COUNCIL ASSESSMENT REPORT

Panel Reference	2018SSW006
DA Number	DA-43/2018
LGA	Liverpool City Council
Proposed Development	Demolition of existing structures and removal of all vegetation, the construction of four x part 3 and 4-storey residential flat buildings containing 162 residential apartments, basement carparking, landscaping, and road construction and civil works.
Street Address	185 FIFTH AVENUE, AUSTRAL (LOT 1115 DP 2475)
Applicant/Owner	GM ARCHITECTS PTY LTD
Date of DA Lodgement	17 January 2018
Number of Submissions	Nil
Recommendation	Refusal
Regional Development Criteria (Schedule 4A of the EP&A Act)	The proposal has a capital investment value of over \$30 million.
List of all relevant s79C(1)(a) matters	<p>1. <i>List all of the relevant environmental planning instruments: s4.15(1)(a)(i)</i></p> <ul style="list-style-type: none"> • State Environmental Planning Policy (Sydney Region Growth Centres) 2006 (SEPP SRGC). • State Environmental Planning Policy No.65 – Design Quality of Residential Apartment Development (SEPP 65). • State Environmental Planning Policy No.55 – Remediation of Land (SEPP 55). • State Environmental Planning Policy (Building Sustainability Index: BASIX

Figure 5: Flood Impact Mapping and extent of Flood Impact below a 1%AEP flood.

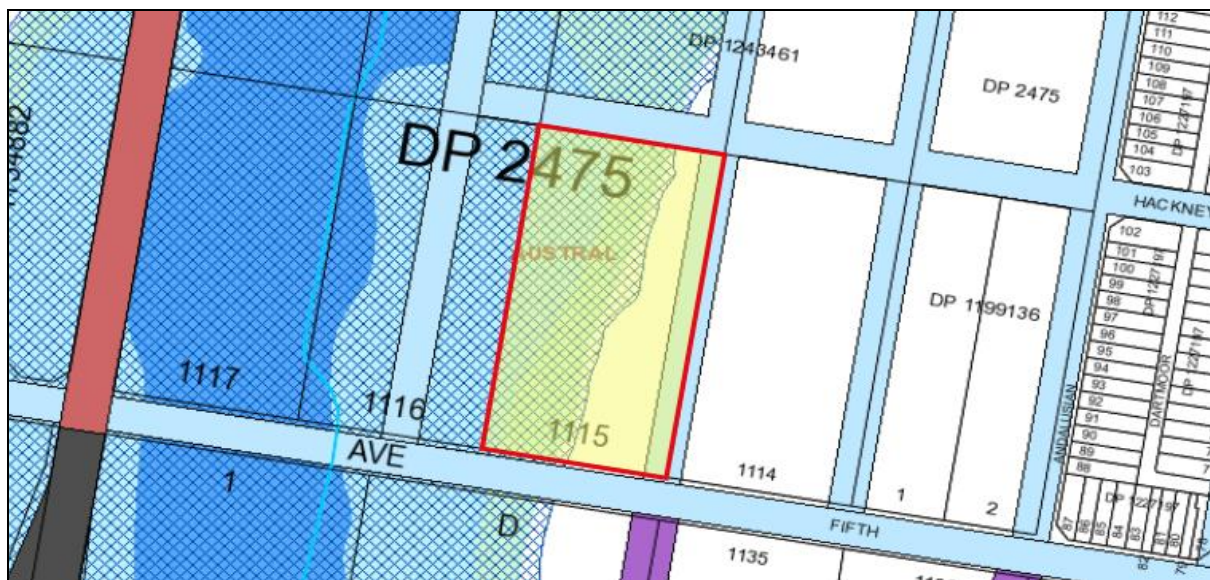
The land is flood prone and bushfire affected. Council's Floodplain Engineers provided comment requesting more information to be lodged with Council, which was requested of the applicant but which has not been forthcoming.

Figure 7: Site Plan of originally proposed development.

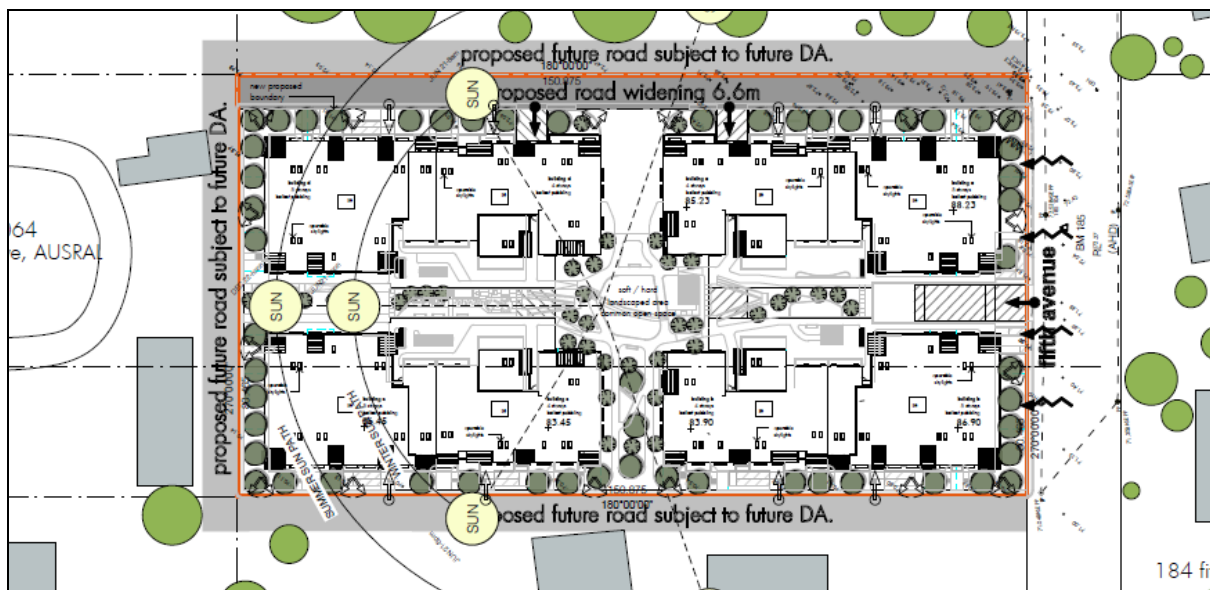
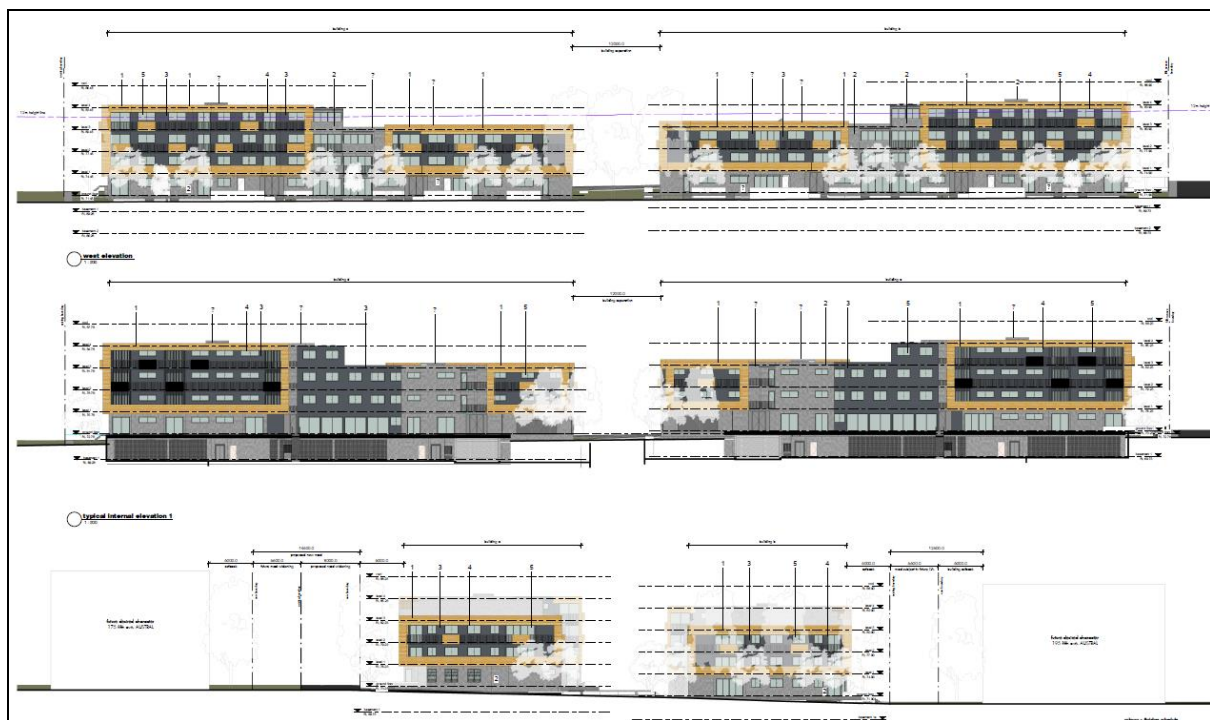
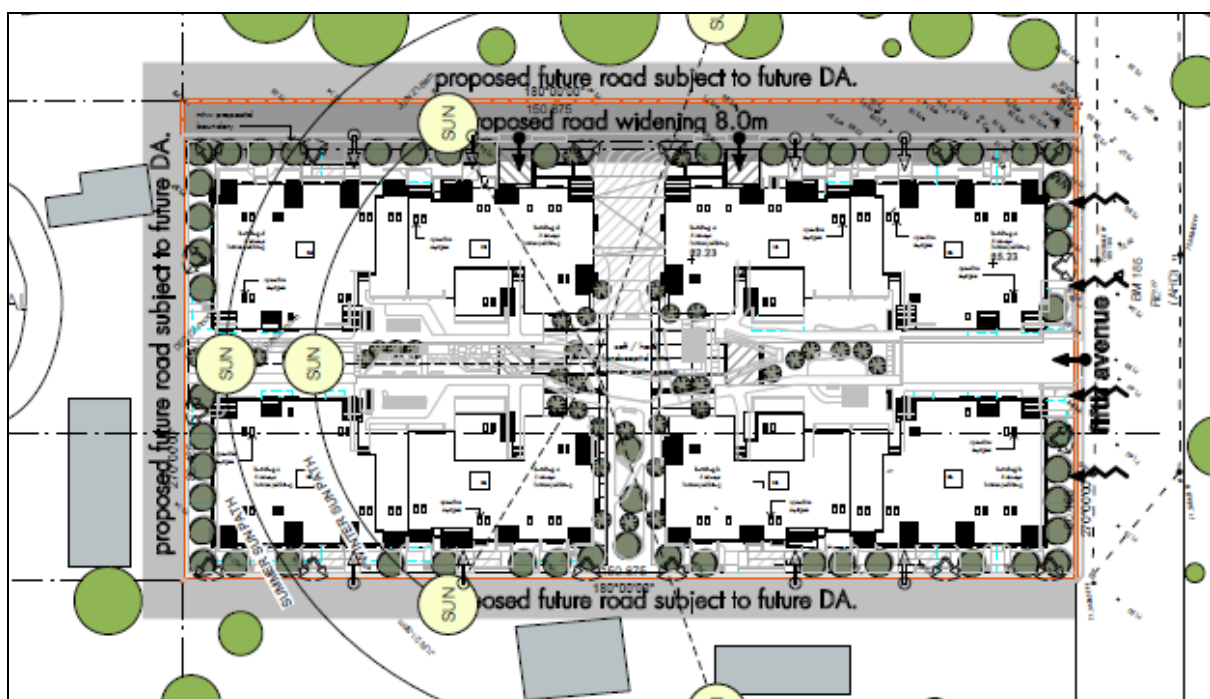
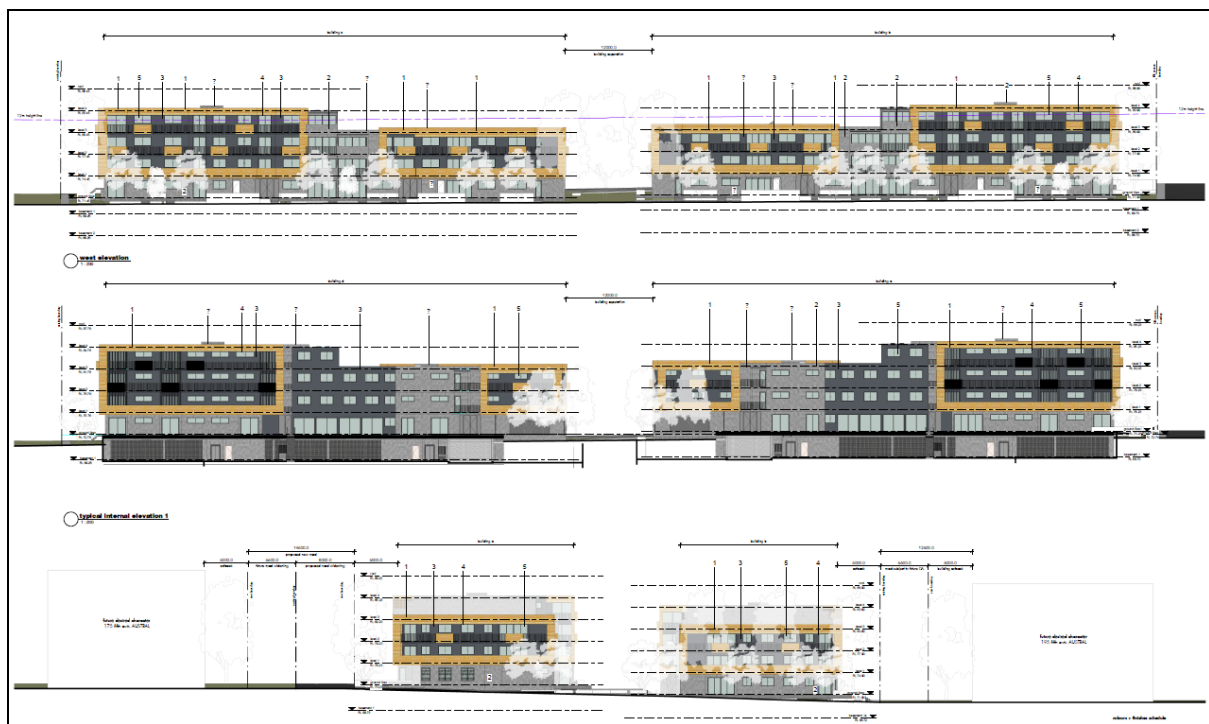
Applicant provided a response to the above correspondence in the form of plans of a downscaled development for the site which retains the same footprint but reduces the proposed development from 222 to 162 apartments, reduction from 2 basements levels to 1, widening of the proposed road in the east of the site to 8 metres, and decrease in overall height from a 4-5 storey to a 3-4 storey development (**Figures 9 and 10**). No technical details were submitted as requested.

Figure 11: Proposed Removal of Existing Trees (north to right)

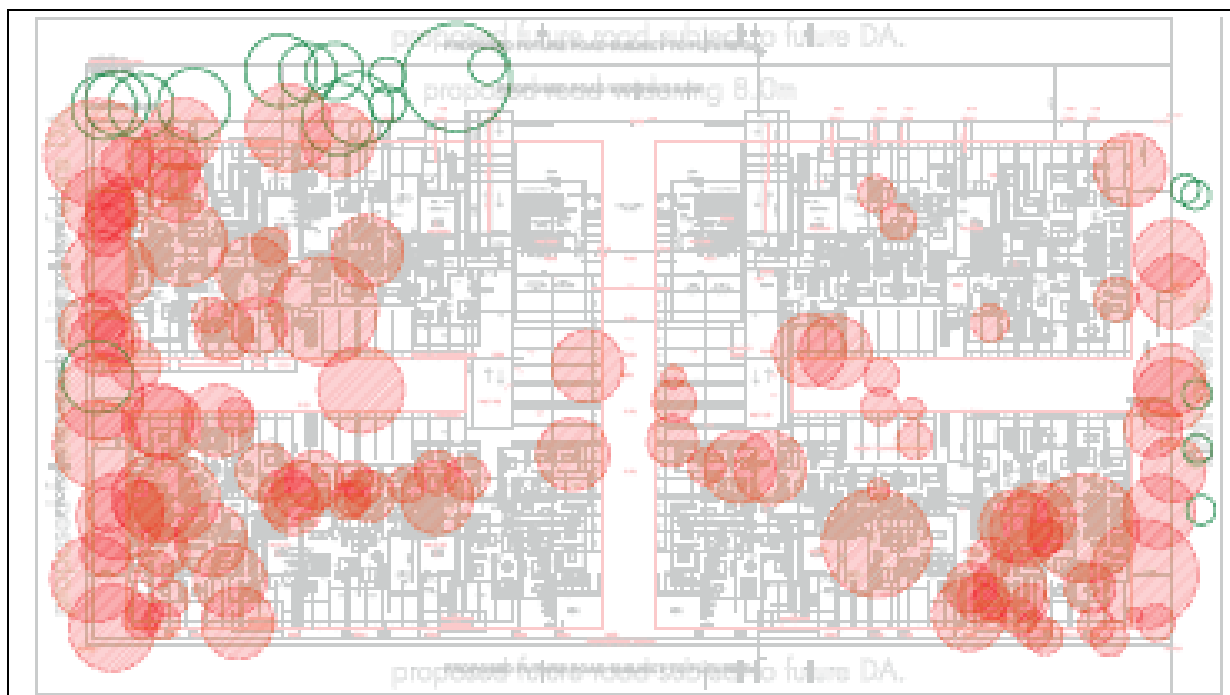
<p>accommodate the development, the applicant has not made any attempt to incorporate any existing trees within the development, which would be considered a reasonable response to the site, given the large size of the lot and the ability to orientate new development around such vegetation. The submitted arborist report does not sufficiently explain why the trees cannot be retained, instead reporting that only 34 of the 164 trees are in poor conditions, and that only 4 are to be retained. The report also recommends the removal of 18 trees on adjoining site for which there is no adjoining owner's consent provided.</p>

Figure 18: Extract of the ILP Road Network affecting the site

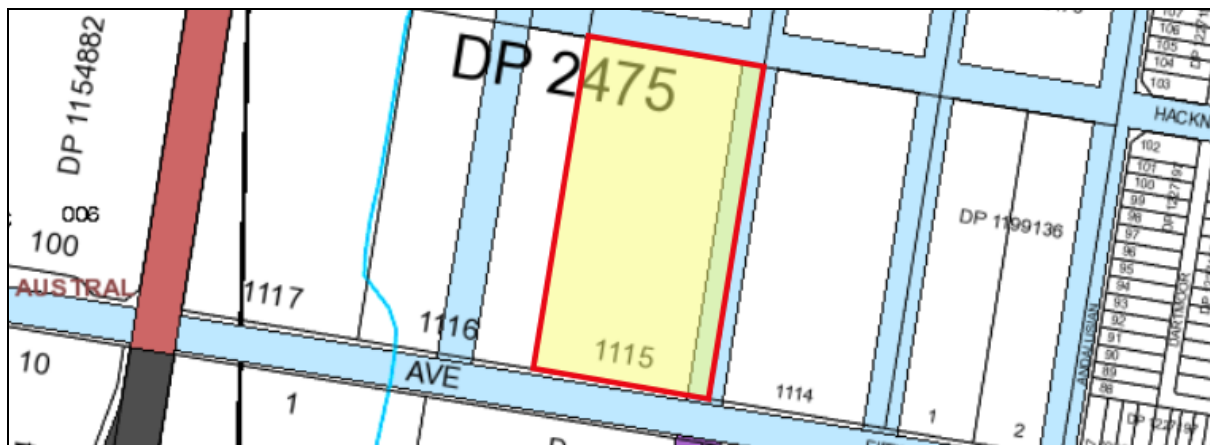
The ILP for the this site indicates a local road (16m width) within the eastern side boundary of the site to an extent of 10m, such that the development is expected to provide the construction of 10m of the road reserve, which includes 3.5m of footpath, verge and nature strip and 6.5m of road pavement, view Figure 17 (below).

Figure 19: Extract of the Ground Level Plan showing 8m of road construction in the eastern portion of the site and a re-located future road to be constructed by a future developer on the western side of the site

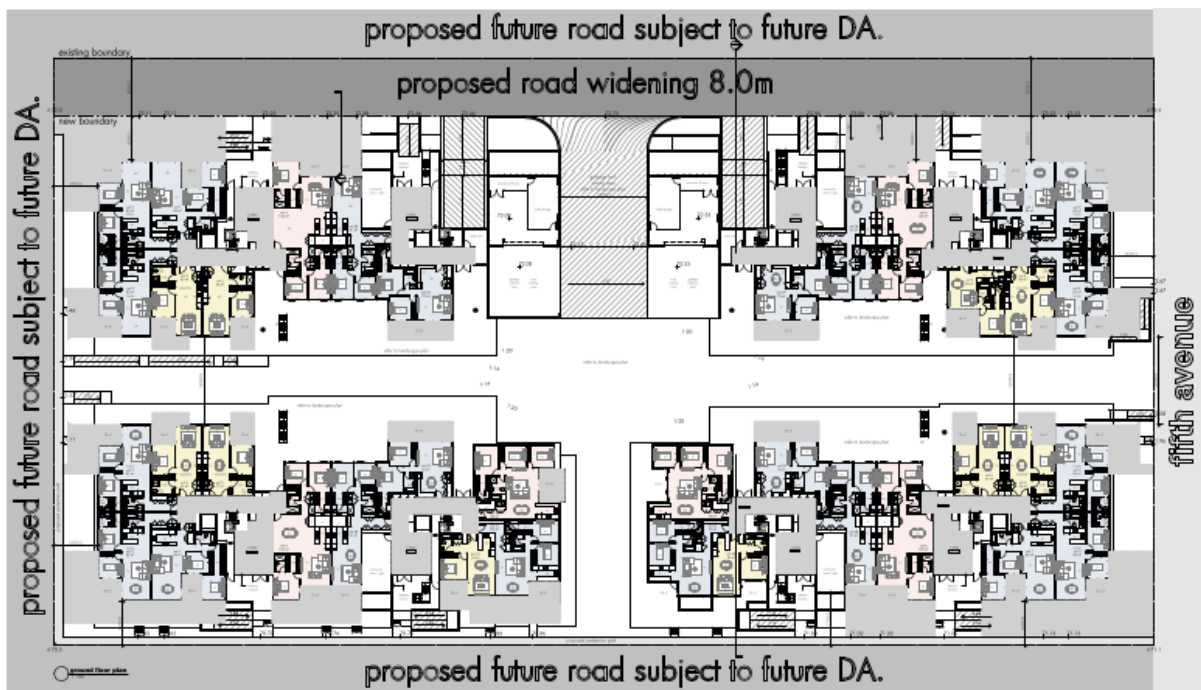
The proposal relies upon the construction of only 8m of road reserve, effectively requiring an adjoining developer to construct an additional two metres more than as shown in the ILP, and for which there is no adjoining owner's consent. Further as shown on the submitted Civil Works Plans, to make the proposed development temporarily viable, a temporary turning head is proposed on that land without such consent from the owners. Additionally, the proposed 8m road reserve would result in only 4.5m width carriage-way in the interim scenario, which does not comply with Council's policy to require two way movement (minimum of 5.5m).

Figure 20: Extract of the Civil Works Plan showing temporary turning head on an adjoining site without obtaining any adjoining owner's consent.

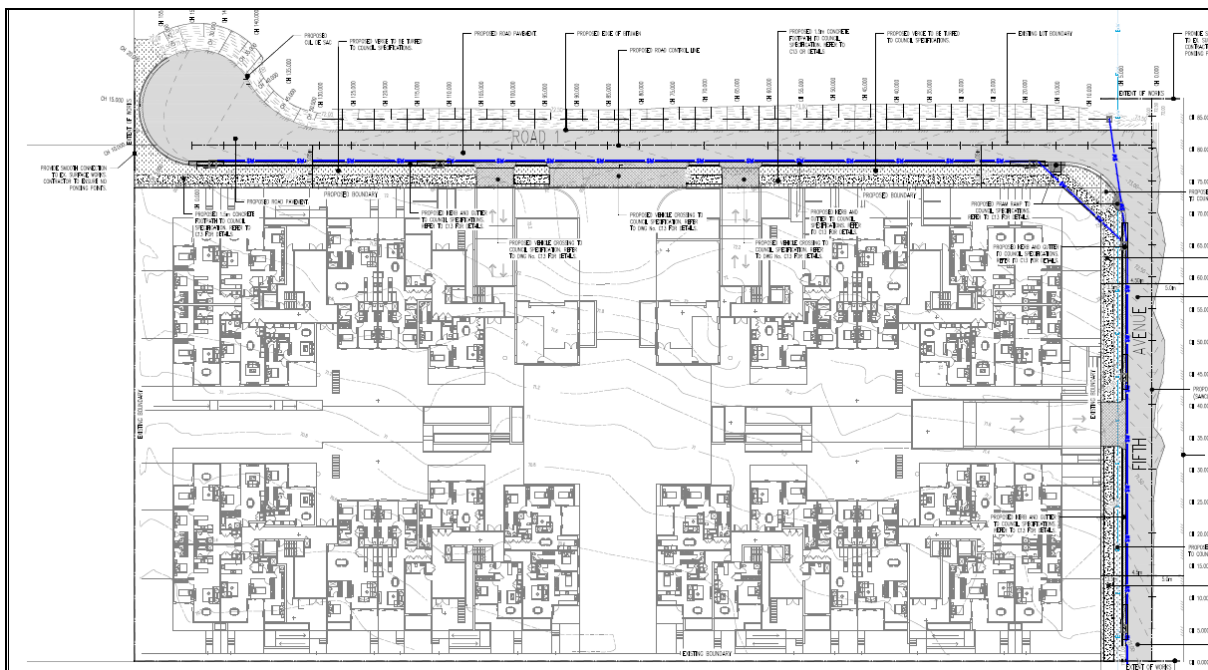
Otherwise, the development proposes the relocation / addition of a road (in variation to the ILP) on the western adjoining owner's property without any consent, to make the development viable.

The applicant has not provided appropriate justification for the variation sought and as such the development is unsupportable due to the following implications and impacts of the proposal;
